Project	IEEE 802.16 Broadband Wireless Access Working Group < http://ieee802.org/16 >	
Title	Service Primitives for Accounting	
Date Submitted	2005-07-12	
Source(s)	Yun Won Chung, PhD	yun.chung@etri.re.kr
	Jee Hyeon Na,	jhna@etri.re.kr
	Sang Ho Lee, PhD	leesh@etri.re.kr
	ETRI 161, Gajeong-dong, Yuseong-gu, Daejeon, 305-700, Korea	
		Voice: +82-42-860-5244 Fax: +82-42-861-1966
Re:	Call for Comment on P802.16g Baseline Document	
Abstract	This contribution proposes service primitives for accounting.	
Purpose	The document should be considered during the resolution of comments on the baseline document.	
Notice	This document has been prepared to assist IEEE 802.16. It is offered as a basis for discussion and is not binding on the contributing individual(s) or organization(s). The material in this document is subject to change in form and content after further study. The contributor(s) reserve(s) the right to add, amend or withdraw material contained herein.

Service Primitives for Accounting

[Modify section 14.5.3 as follow]

Fig.4 - Accounting Primitive Initiated by BS

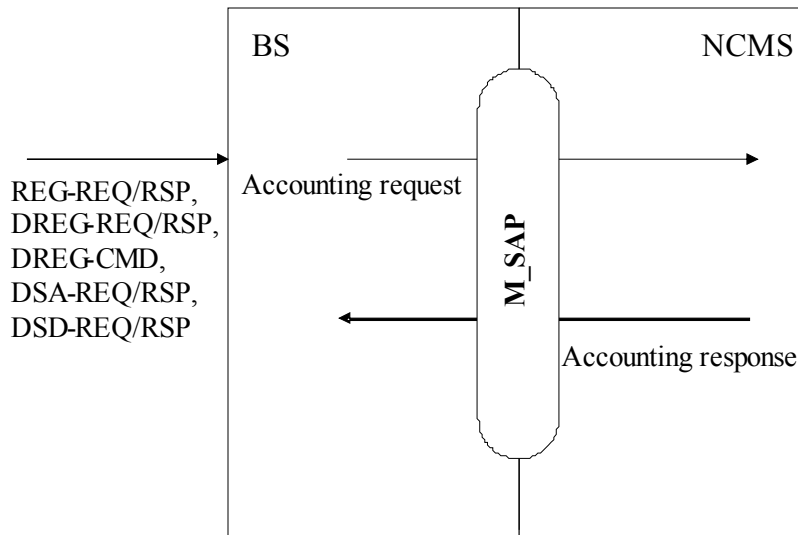
Accounting primitives consists of Accounting request and Accounting response, as shown in Figs. 4 and 5. Accounting attributes in Accounting request and Accounting response are basically based on the attributes defined in RADIUS or Diameter, and new accounting attributes such as Service Flow Identifier, Service Class Name, Service Flow Scheduling Type, and Minimum Reserved Traffic Rate are additionally defined for IEEE802.16 WMAN specific application. Thus, the proposed accounting can accommodate various services characteristics of IEEE 802.16 WMAN.
